ADDENDUM NO. 1
CORPORATION OF THE TOWNSHIP OF KILLALOE-HAGARTY-RICHARDS
ROUND LAKE CENTRE BOAT LAUNCH UPGRADES
RFT-05-2026

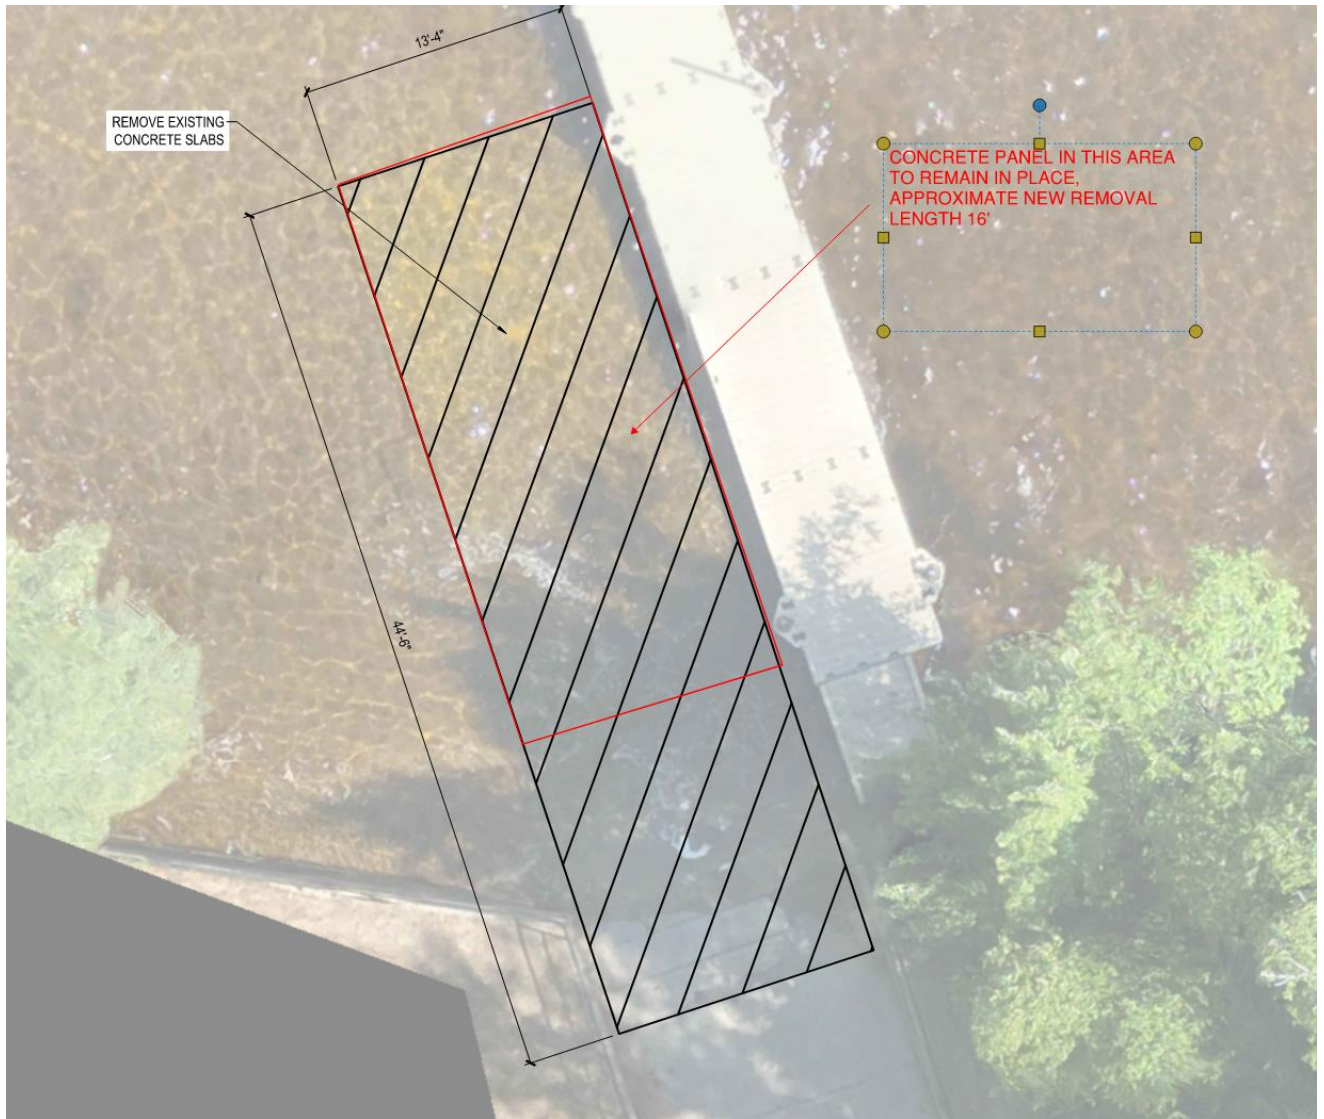
1. Revise precast ramp lengths from 13'-2" to 14'-0" (See Below)
2. Revise width of riprap shoulder on the dock side from 24" to 12". Other side remains 24". (See below)

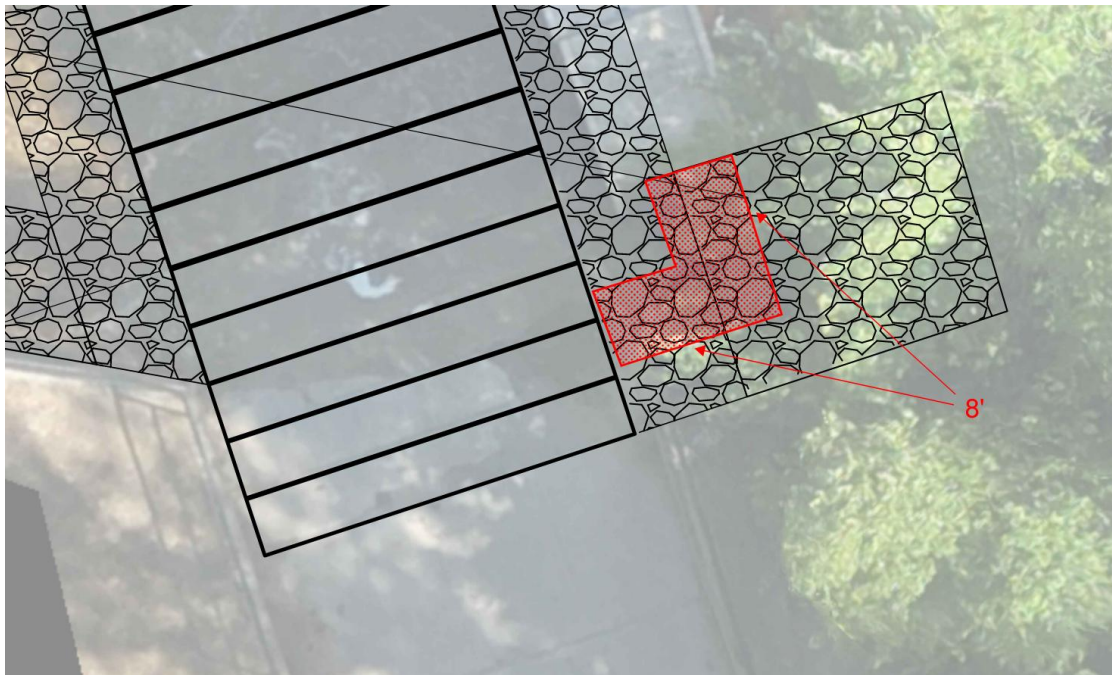
3. Add provisional item for building a cofferdam in the case of above average water levels. Please add price for a sandbag cofferdam 24" high and 60' in length.
4. Revise additional rip rap area from 100 sq.ft. to 200 sq ft.
5. Reduce amount of concrete to be removed from 44'-6" to 16'-0" (See below)
